City of Richmond
Planning and Development Department

Report to Committee

File: RZ 05-317846

Re: Application by ATI Investments Ltd. for Rezoning at 8420 Westminster Highway and 6140, 6160, 6180 Cooney Road from "Townhouse & Apartment District (R3)" to "Comprehensive Development District (CD/202)"

NORTH
ELEVATION

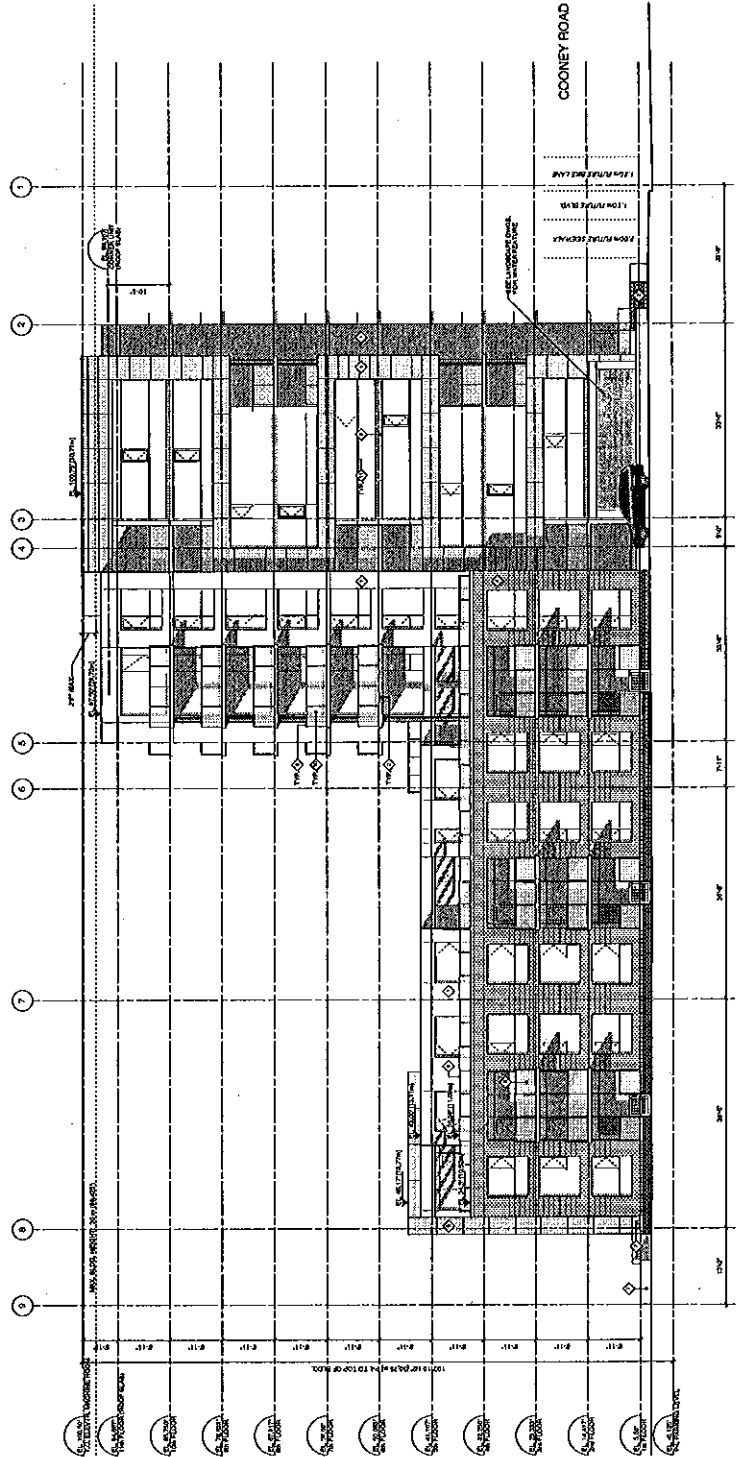
- Recommend exploring the possibility of incorporating additional brick cladding. Although some material relationship with the buildings in the area has been achieved, it is still desirable to further the use of brick cladding in parts of the building along Cooney Road to reinforce this relationship to the surrounding built context.

SOUTH
ELEVATION

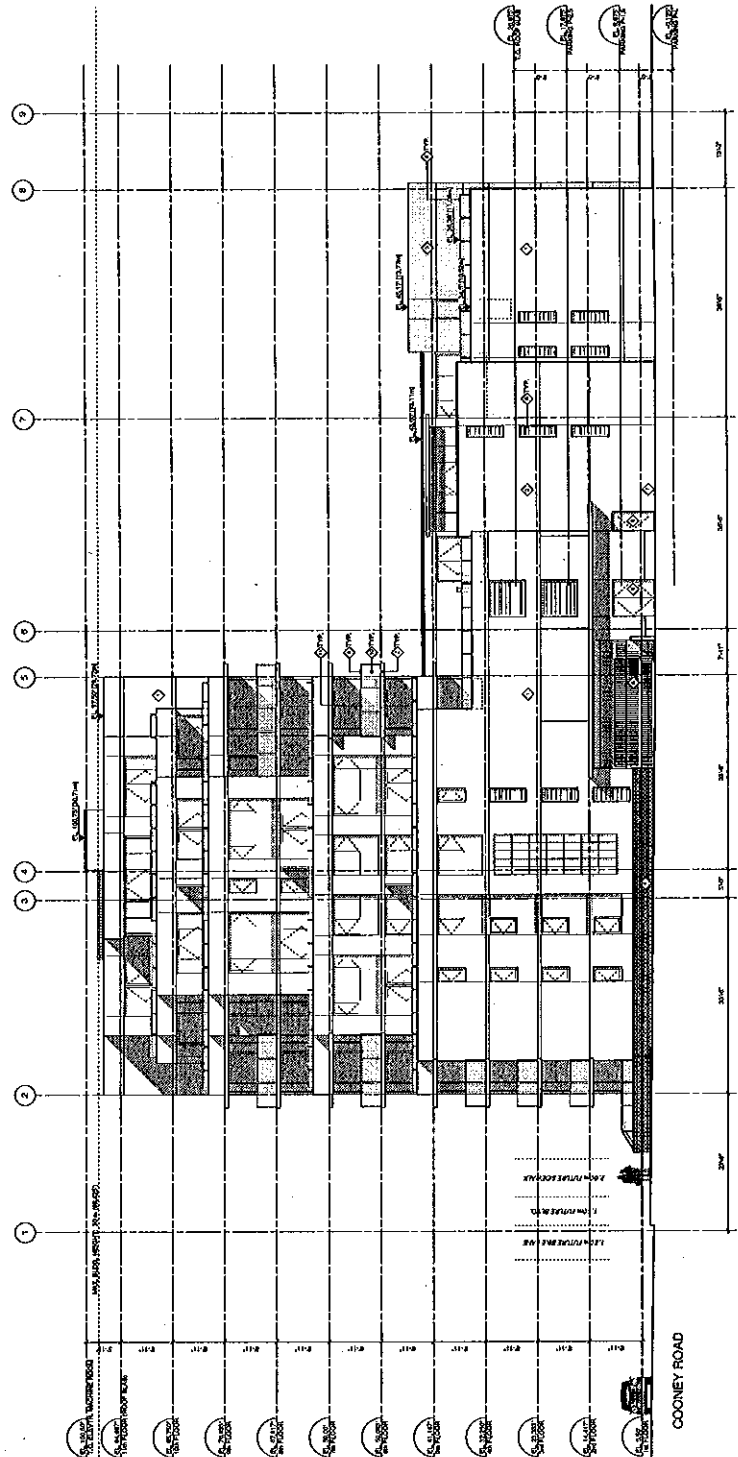
- Design development to the south elevation, especially the portion closer to Cooney Road required to reflect and bring some of the features of the west elevation around the corner, along a portion of the lane. This portion of the building will be exposed to direct views from pedestrians from the street.
